**RE: SECTION 72 AMENDMENT APPLICATION
PLANNING PERMIT PP-305-2023/A
9 BROWN STREET PORTARLINGTON**

Further to the Request for Further Information dated 31st March 2026, please see attached Architectural Drawings (Revision E: 18.05.2026), amended SMP and WMP. Documents have been amended as follows:

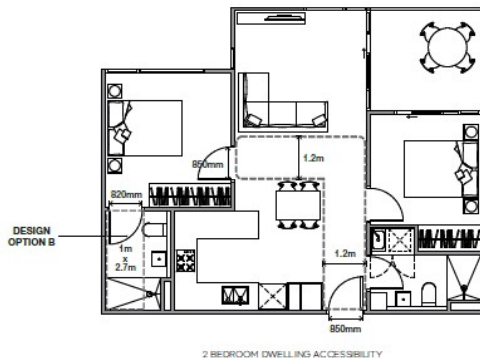
6. Please note, the permit on the subject site predates the permit on the adjacent land. Further, these matters were considered at VCAT, and we note that permit conditions 1(k) and 1(n) relating to privacy have been appropriately implemented. The southern interface of 5-7 Brown Street has also been screened (both windows and balconies) to prevent overlooking. We trust that we have satisfied this requirement and in conjunction with the screening measure implemented at 5-7 Brown Street, can confirm that there will be no overlooking issues.

Our setbacks compliment the approved development at 5-7 Brown Street in the following ways:

- Walls on boundary at Ground Floor to match adjacent walls on boundary.
- Walls on boundary at Level 1 with the exception of a 3.0m deep light court located centrally, approximately aligning with the adjoining 3.0m deep light court.
- A setback of 3.0m at level 2 to match the adjoining setback of 3.0m at level 2.
